UNITED STATES
DEPARTMENT OF THE INTERIOR
BUREAU OF LAND MANAGEMENT
SUNDRY NOTICES AND REPORTS ON WELLS

5. Lease Serial No.	NMNM-66425
6. If Indian, Allottee or Tribe Name	
7. Unit or CA Agreement Name and No.	
8. Well Name and No.	Laguna Salado 22 Federal 6H
9. API Well No.	30-015-37371
10. Field and Pool, or Exploratory	Ingle Wells; Delaware
11. County or Parish State	Eddy NM

TYPE OF SUBMISSION	TYPE OF ACTION			
☒ Notice of Intent	☐ Acidize	☐ Deepen	☐ Production (Start/Resume)	☐ Water Shut-Off
☐ Subsequent Report	☐ Alter Casing	☐ Fracture Treat	☐ Reclamation	☐ Well Integrity
☐ Final Abandonment Notice	☐ Casing Repair	☐ New Construction	☐ Recomplete	☒ Other Rig Layout Change
	☐ Change Plans	☐ Plug and Abandon	☐ Temporarily Abandon	
	☐ Convert to Injection	☐ Plug Back	☐ Water Disposal

5,000 PSI CHOKE MANIFOLD

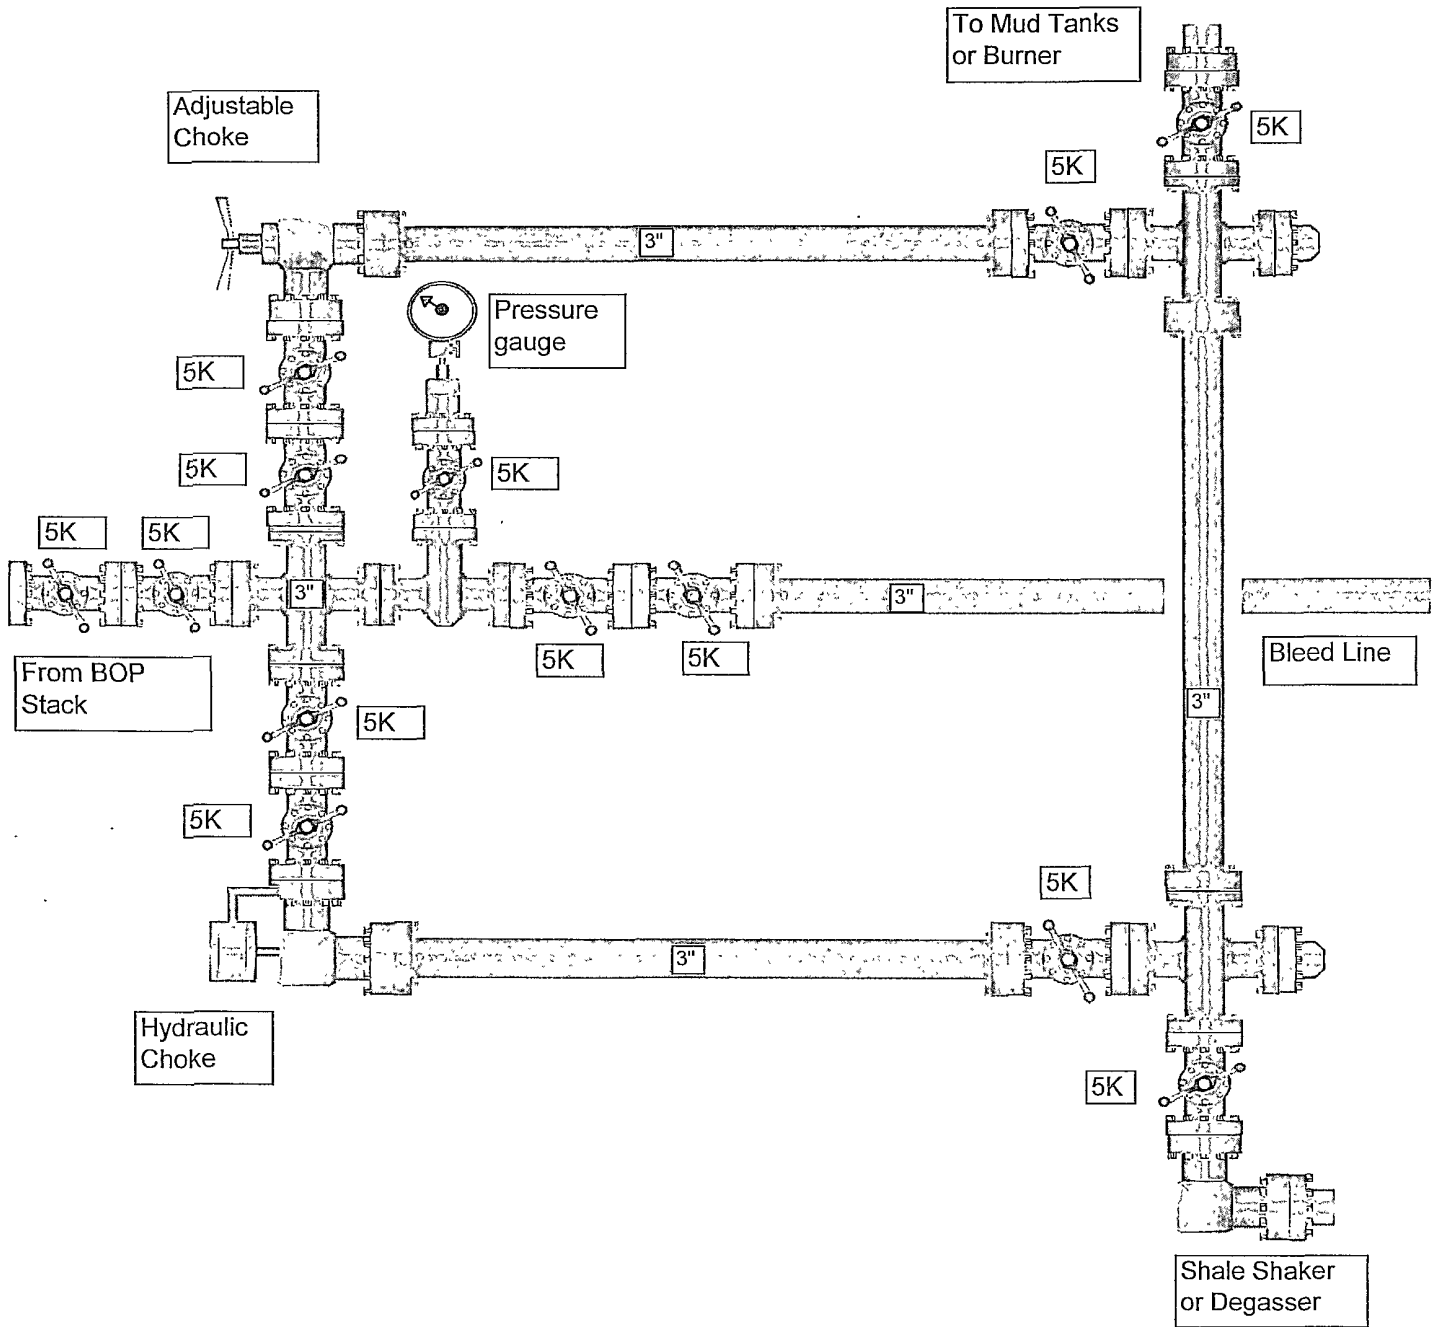
Devon Energy Production Company L. P. respectfully requests to change the rig layout from the McVay #7 to the H & P Rig #214 to drill this well and requests a variance that a co-flex hose may be used between the BOP and the choke manifold. The hose will be kept as straight as possible with minimal turns. CO-Flex Hose Manufacturer: Phoenix Beattie; ~33' (11.43 meters) of co-flex line; 3" coupling w/ 4 1/16" flange on each end - 10,000 psi; Quality Control Inspection & Test Certificate attached; see configuration schematic. Safety clamps are not required since the ends are flanged.

variance approved to use flex line from BOP to choke manifold. Check condition of 4 1/16" flexible line from BOP to choke manifold, replace if exterior is damaged or if line fails, test line to be as straight as possible with no hard bends.
